## *Ducted Systems Technical Services Service Tips Letter*

Letter: **ST-007-2018**

Subject: **Condensate dripping issue with Residential Early production model CM indoor coils applied in a horizontal application.**

Product: Residential CM Model cased coils: AP, AE, AVC, RFCX\*\*22 air handling units.

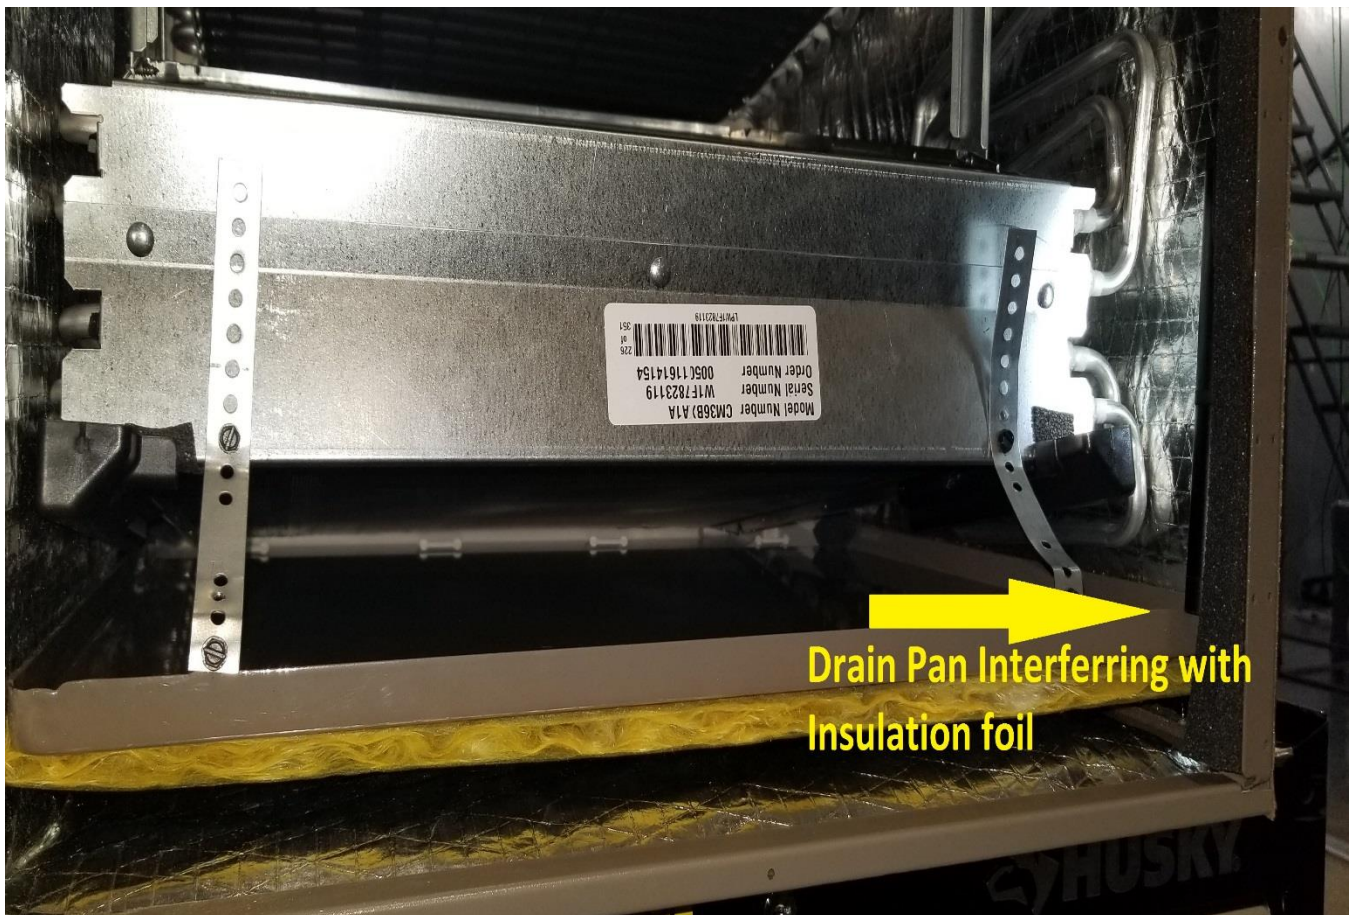
We have received some reports of condensation dripping from the distributor assembly, distributor tubes, suction header and the TXV body of the residential indoor model CM coil when applied in a horizontal application. The reports indicate small amounts of condensation not being captured by the horizontal drain pan, but falling past the pan into the coil cabinet.

Through our investigation, we discovered that the distributor assembly, tubes, suction header and TXV body of the coil may be pressing against insulation of the front panels of the coil case, which is shown below.

When condensation is formed during normal operation, the condensation has the ability to make contact with the insulation face and travel down the foil surface. Due to the design of the first generation horizontal drain pan, the drain pan may be unable to capture all of the condensation coming off the front of the coil.

Based on these findings, Design Engineering implemented a wider horizontal condensate drain pan in July of 2017. The drain pan can be identified by the edge connected to the horizontal pan straps. The first generation drain pans had a 45-degree edge. The current drain pan has a 90-degree edge. The drain pan edge was changed to improve condensate management within the pan. Shown below is a picture of the current drain pan that now has an interference fit with the insulation on the back coil cabinet and front panel. Coils produced in August 2017 (W1H7) and later contain the new wider drain pan.

A component that can assist with managing the condensation into the horizontal drain pan when applied in horizontal applications is the “Horizontal Pan Angle Flange” and 3 “S-clips.” This item can be found in Source1 kits S1-37339479001, S1-37339472001, S1-37339473001, and S1-37339475001. Install the pan angle by following the installation instructions included with the Source 1 kit. For most applications, the pan angle must be cut to the correct length. Condensate will be more effectively captured and directed into the horizontal drain pan. See photo below of the Horizontal Pan Angle Flange after installed onto the drain pan edge.
